# **FIRE SAFETY INSPECTION REPORT**

## **DIP KNITWEAR LTD.**

**HAMID PLAZA-2, DAGERCHALA ROAD, NATIONAL  
UNIVERSITY, GAZIPUR SADAR, GAZIPUR**

May 11, 2014

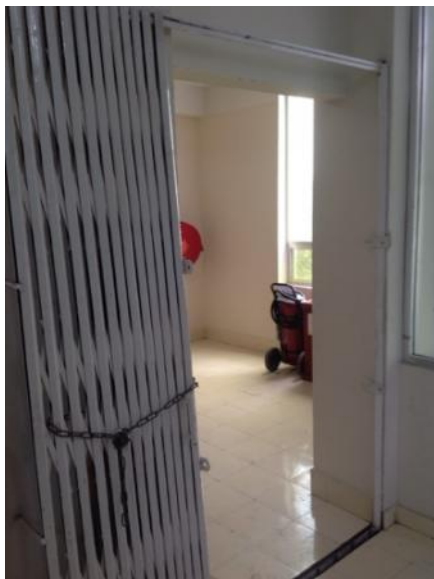
F-4	Fire Rated Construction	Areas used for storage are not separated by fire-rated construction. This was located in the second floor work stations and the first floor south west side of the building.	Provide dedicated storage rooms separated by minimum 1-hr fire-rated construction.  Where separate storage rooms are not feasible, provide defined storage areas and limit the storage arrangement as follows: Maximum height of 2.4m and maximum area of 23m <sup>2</sup> .  Separate areas of unenclosed combustible storage by a minimum clear distance of 3m.	Within 3 months
-----	-------------------------	--	--	-----------------

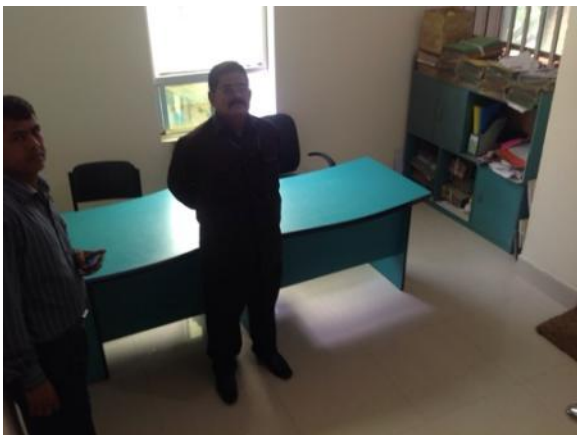
Storage was located in the exit stair in the north exit first floor landing.

Remove all storage from exit stairs and egress paths.

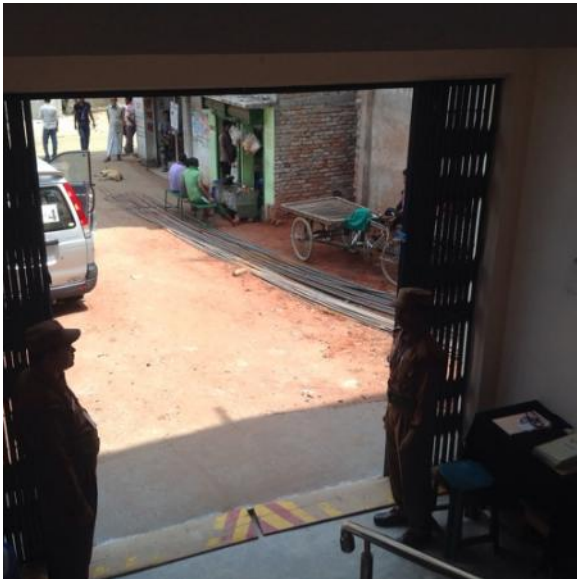
Egress doors / gates with locking features are provided at building exits, exit stairs, along egress routes, exit discharge throughout the facility.

Remove locking features from all egress doors / gates.

If locks are required for security reasons, utilize special door locking features complying with NFPA 101.
